Case Number ACP – 324290-26

Lissinagroagh Wind Farm

Response to Submissions Report

FuturEnergy Ireland

Figure 2-1: Revised Noise Survey Locations

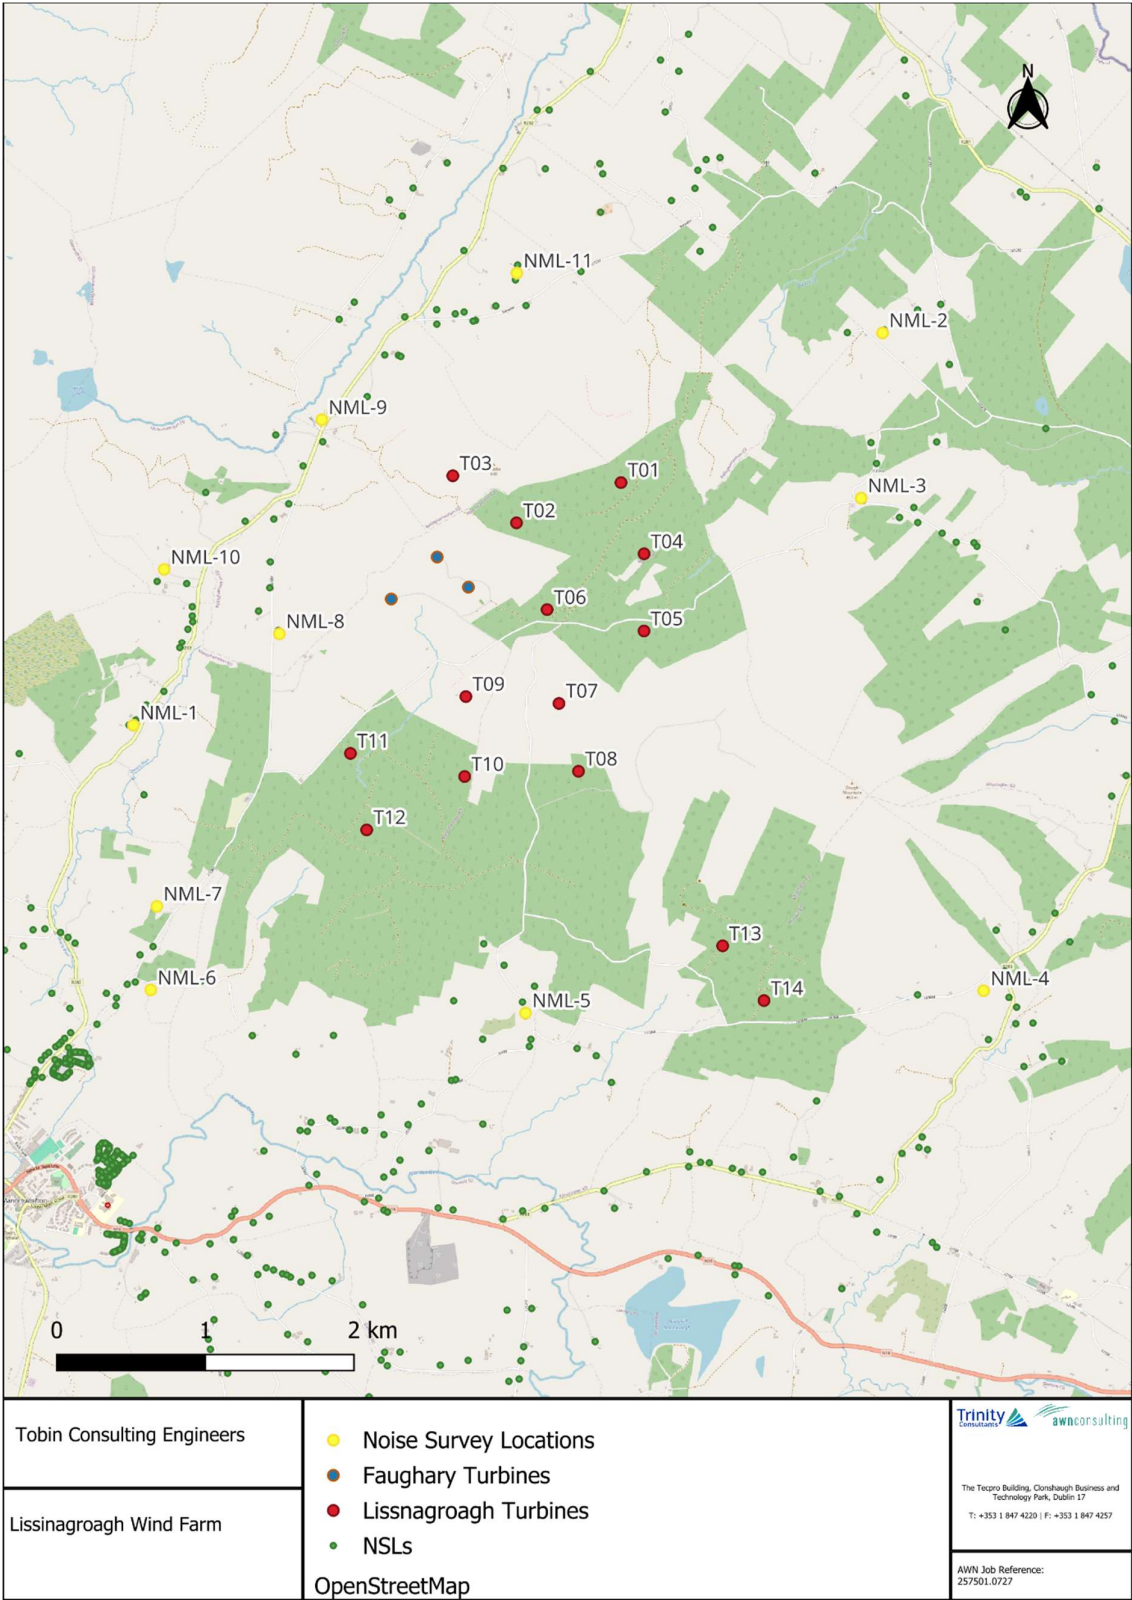
Clarify with regard to the Noise Monitoring Locations Map (Figure 9-2) NML-10, NML-2, NML-4 and NML-5 were not located between the nearest proposed turbine and the nearest dwelling that would be considered the Nearest Sensitive Receptor. Also from the map it appears there is a dwelling West of Turbines T11 and T12 which the noise monitoring assessment did not take into consideration.

The revised Appendix 9-3 (see Appendix B herein) presents an updated figure showing noise survey locations and also coordinates in Table 2.3 therein. The revised coordinates for the noise survey locations are also presented in Table 2.2 and in Figure 2.1.
